RE: 30 Valley Road - F/23/95474

GRAHAM ASH ARCHITECTS LTD. COMMENTS ON CHRIS STRINGER'S REVIEW OF ALDERWOOD CONSULTING'S SUBMISSION TO EBC IN SUPPORT OF THE APPLICATION.
WE HAVE HIGHLIGHTED THE KEY STATEMENTS BY ALDERWOOD AND POINTS RAISED BY CHRIS IN YELLOW.

APPENDIX 1 – SUGGESTED DETAIL TO AVOID INVASIVE DISRUPTION/DAMAGE TO EXISTING ROOTS WITHIN THE RPZ. SECTION THROUGH PROPOSED NEW DWELLINGS USING CONCRETE OR HELICAL STEEL PILES

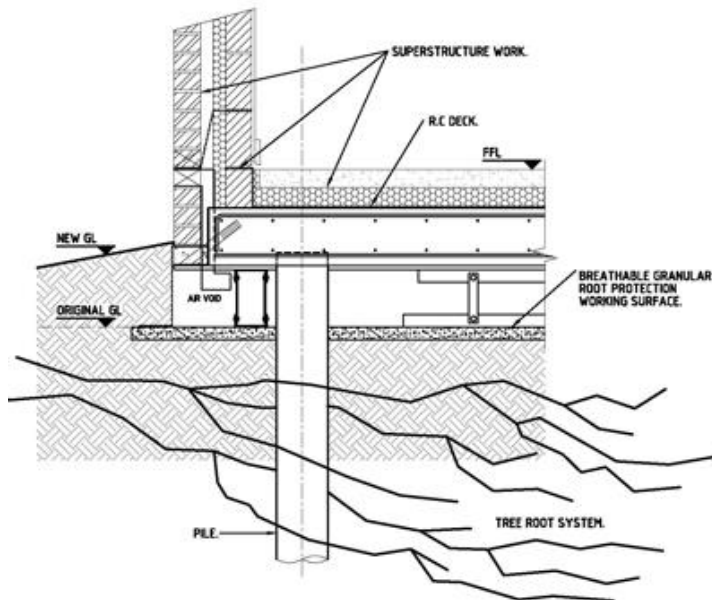
1.2 The paragraph goes on to state that piles (or similar) can be utilised for construction within an RPA: *"The principles will be that except for the localised piles or piers there should be no excavation into ground previously undisturbed."*

1.02 This is theoretically acceptable, but it has not been demonstrated that levels will be workable on this site specifically. For example, the dwelling in plot 3 would have to be elevated, which may have impacts on ridge heights and thus on other elements of planning.

It is proposed that the foundations for plots 2 and 3 (and possibly Plot 1) will be piled. Helical piles offer some advantages. The ground levels will remain as existing and no invasive excavation is proposed.

The site will have protective reinforced mats to minimise site damage. This will be defined in the construction management plan.

We have attached a sketch section showing the existing and proposed site levels. (appendix 1)
